THE SOD GUY - SALES LOT

CONSTRUCTION DRAWINGS LOT 1, APPALOOSA HIGHWAY 24 SUBDIVISION

SALES LOT - SPECIAL USE
GRADING AND EROSION CONTROL PLAN

SHEET NO:
C-04
DATE:
12/30/18
PAGE NO:
5 OF 6

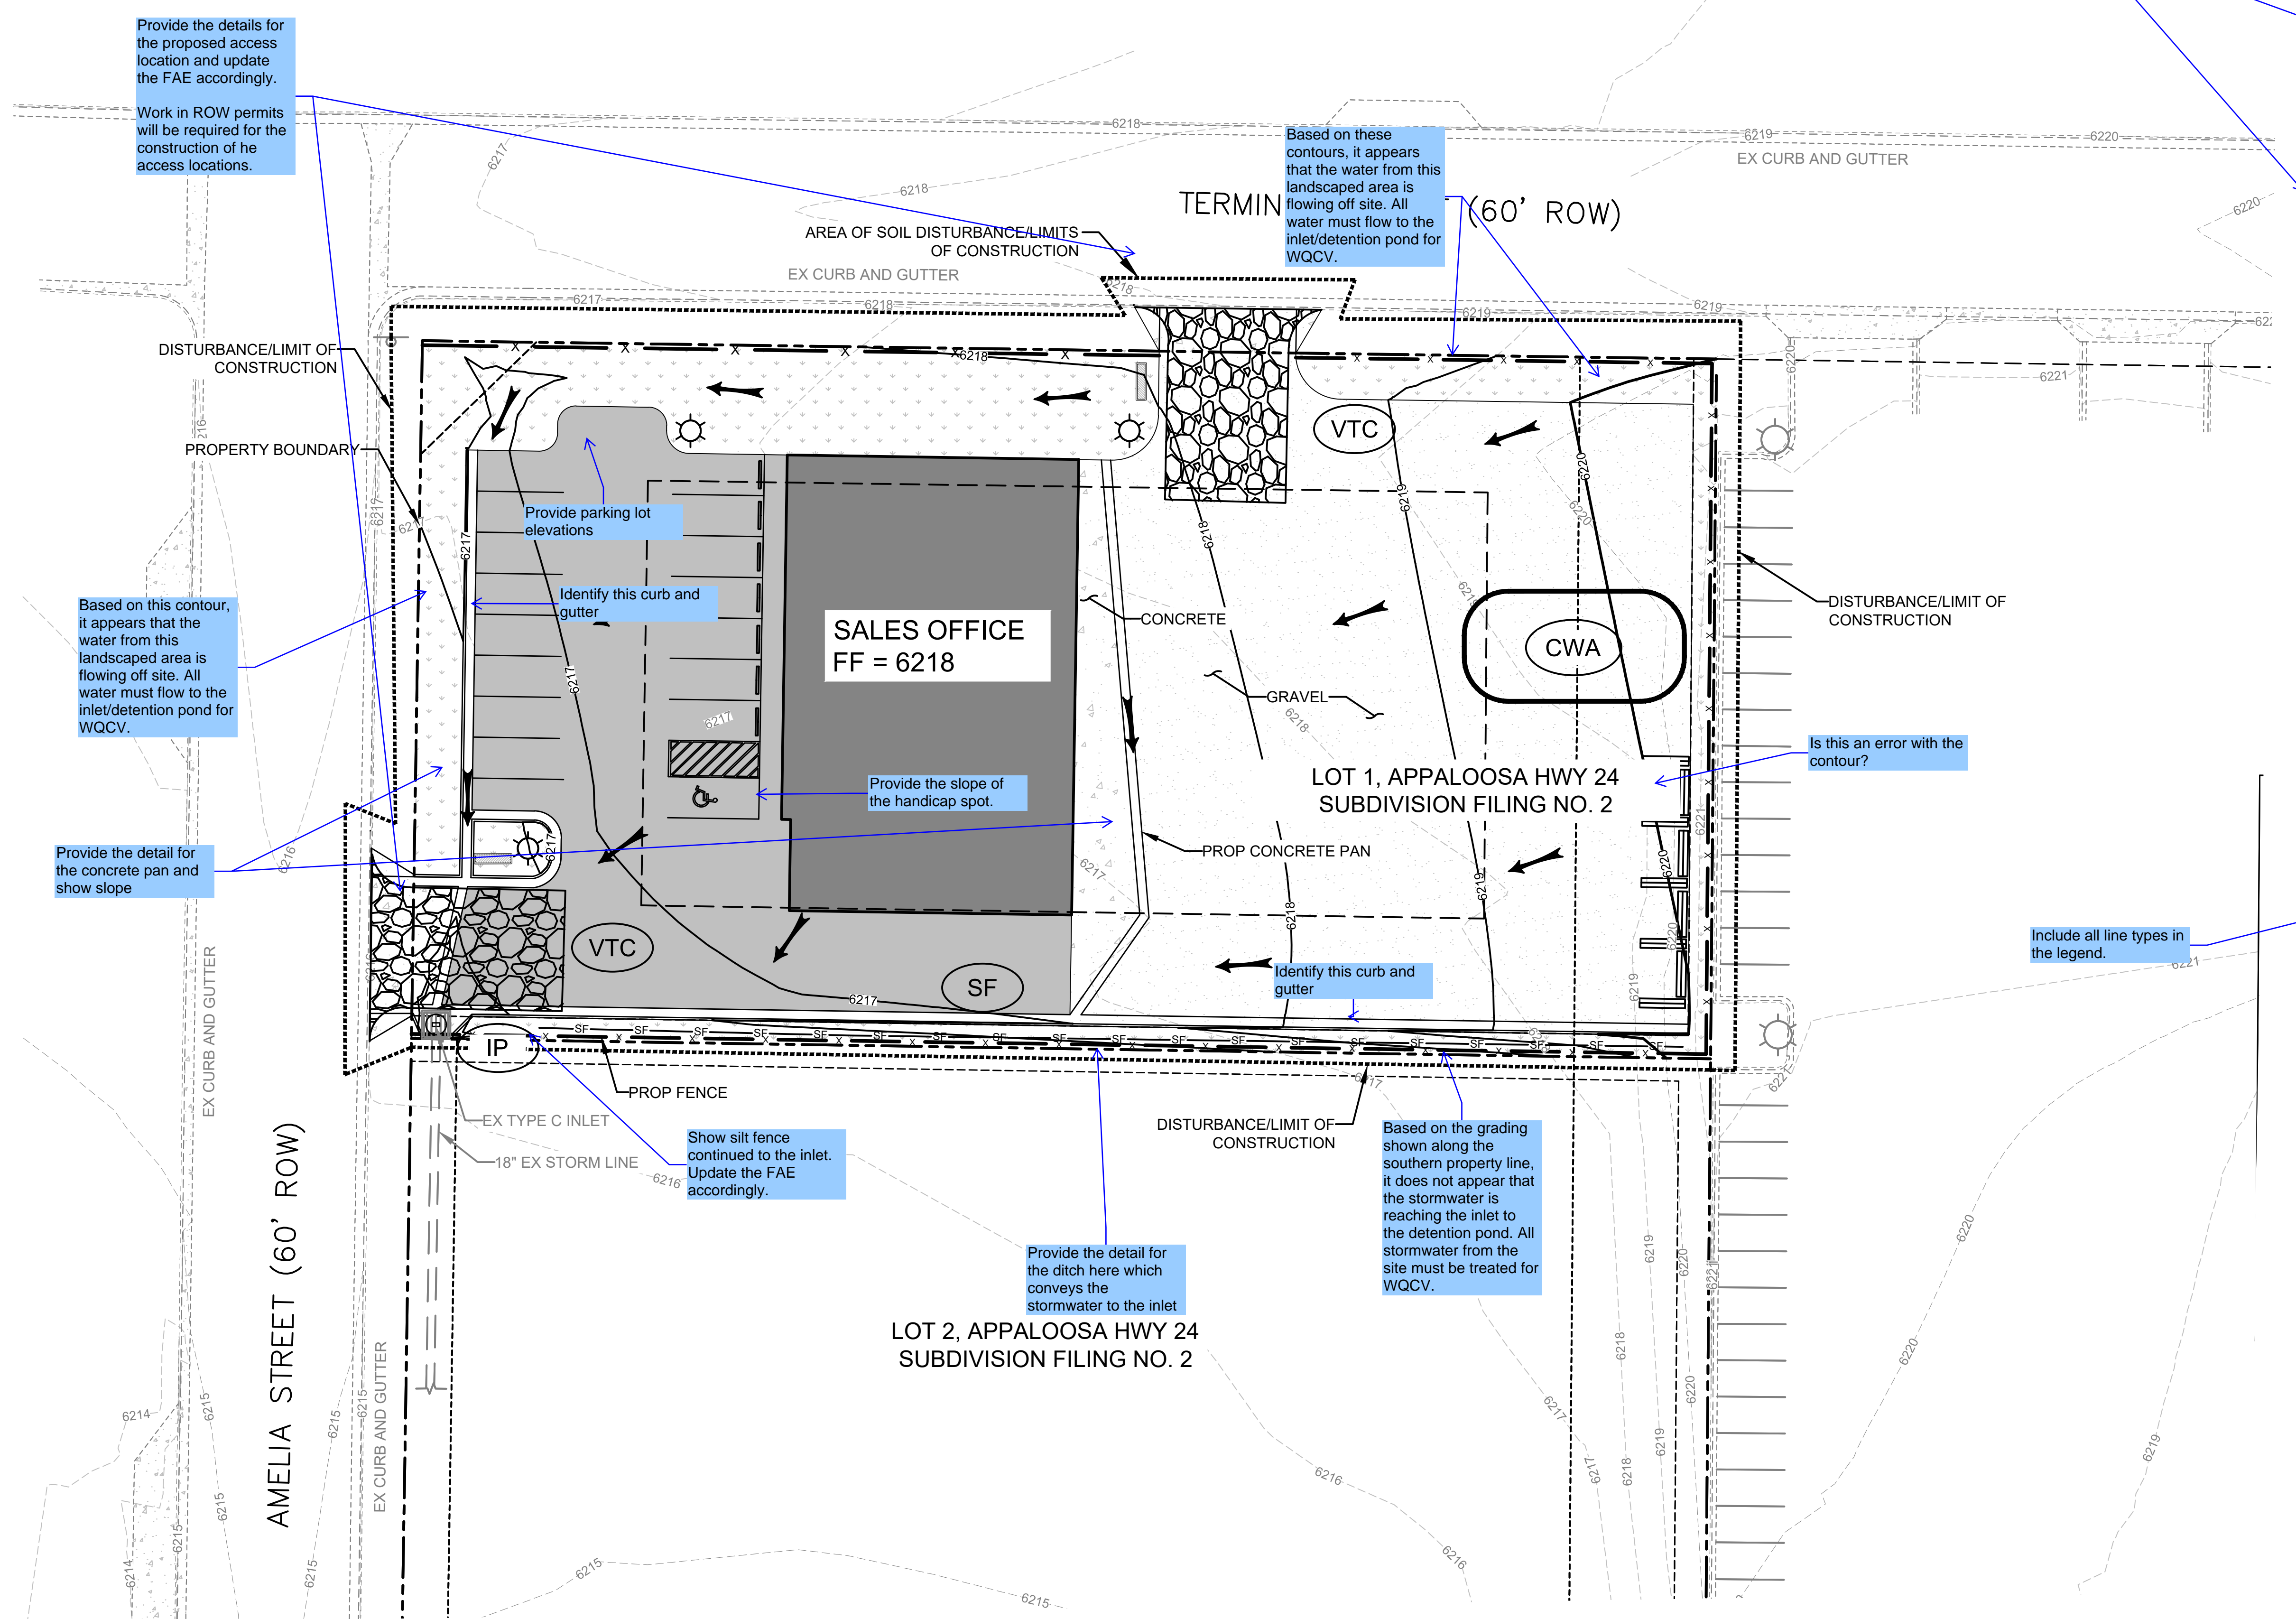
A SWMP must be submitted or a note provided on this grading and erosion control plan that a SWMP must be approved two weeks prior to the beginning of construction.

Provide the following on this plan:
-Vicinity Map
-Standard 27 GEC notes
-Construction BMP standard details
-Reference in note 26 to the geotech report submitted with VR1813
-Easements

Provide the details for the proposed access location and update the FAE accordingly.

Work in ROW permits will be required for the construction of the access locations.

Based on these contours, it appears that the water from this landscaped area is flowing off site. All water must flow to the inlet/detention pond for WQCV.

Based on this contour, it appears that the water from this landscaped area is flowing off site. All water must flow to the inlet/detention pond for WQCV.

Provide the detail for the concrete pan and show slope

Provide parking lot elevations

Identify this curb and gutter

Provide the slope of the handicap spot.

Identify this curb and gutter

Show silt fence continued to the inlet. Update the FAE accordingly.

Provide the detail for the ditch here which conveys the stormwater to the inlet

Based on the grading shown along the southern property line, it does not appear that the stormwater is reaching the inlet to the detention pond. All stormwater from the site must be treated for WQCV.

Is this an error with the contour?

Include all line types in the legend.
